ALERT SERVICE BULLETIN

412-20-182

Revision A, 17 December 2020

SUBJECT: ENGINE OIL CHECK VALVE P/N 209-062-520-001,
INSPECTION AND REPLACEMENT OF.

Figure 1. Engine Oil Check Valves Locations

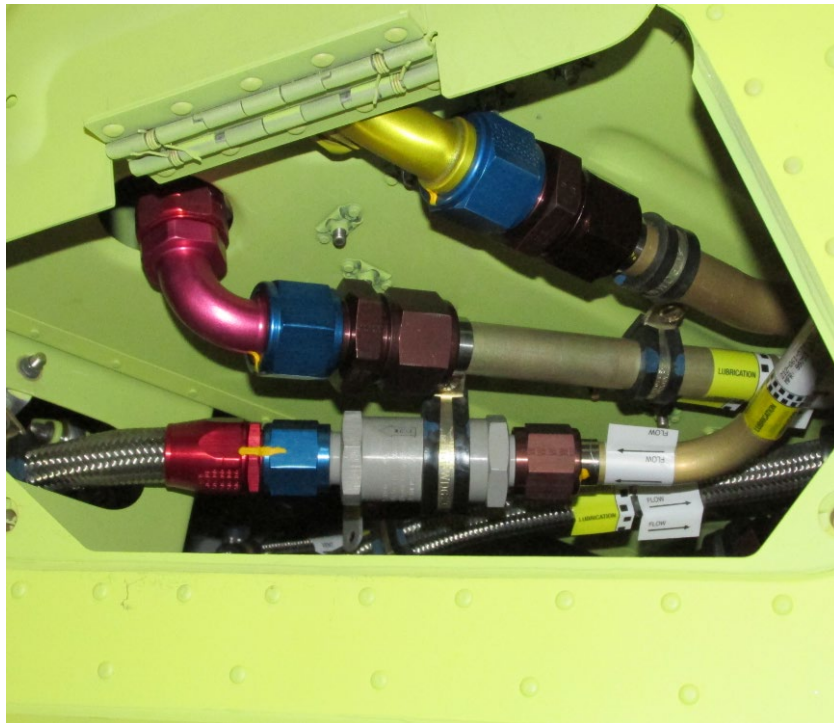
1. Prepare the helicopter for maintenance and gain access to the engine oil check valves. The engine oil check valves are located in the engine reduction gearbox compartment under the oil coolers (Figure 1, Details A and B).

Figure 3. Engine Oil Check Valve Outside Diameter Measurement

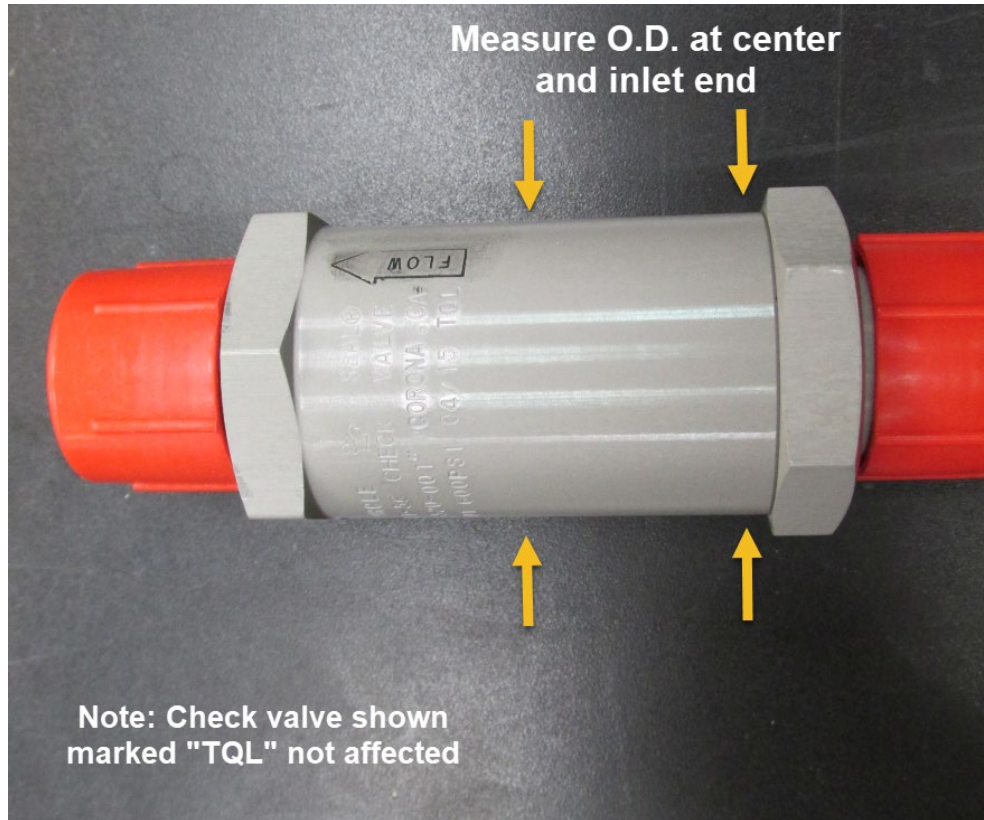
- d. If the dimension measured at the inlet end is greater than 0.003 inch (0.0762 mm) when compared to the measurement at the center, the valve will require replacement. Part III can be accomplished immediately, or Part II can be accomplished until the defective valve can be replaced in accordance with Part III.
- e. If the defective check valve is not replaced immediately, make an entry in the helicopter logbook and historical service records indicating the findings and that Part II must be accomplished every 25 flight hours or 30 days whichever comes first until Part III is accomplished.

1. Prepare the helicopter for maintenance and gain access to the engine oil check valves (Figure 1, Details A and B).
2. Using a strong light source, visually inspect the oil check valves for general condition and oil leaks. Inspect for cracks at the inlet end where the threaded fitting is installed (Figure 3).
3. If a crack is found, replace the check valve prior to next flight. Figure 4 shows an example of a cracked check valve.
4. If no cracks or any other defects that would cause the valve to be unserviceable are found, make an entry in the helicopter logbook and historical service records indicating the findings and that Part II will require accomplishment until Part III is accomplished.
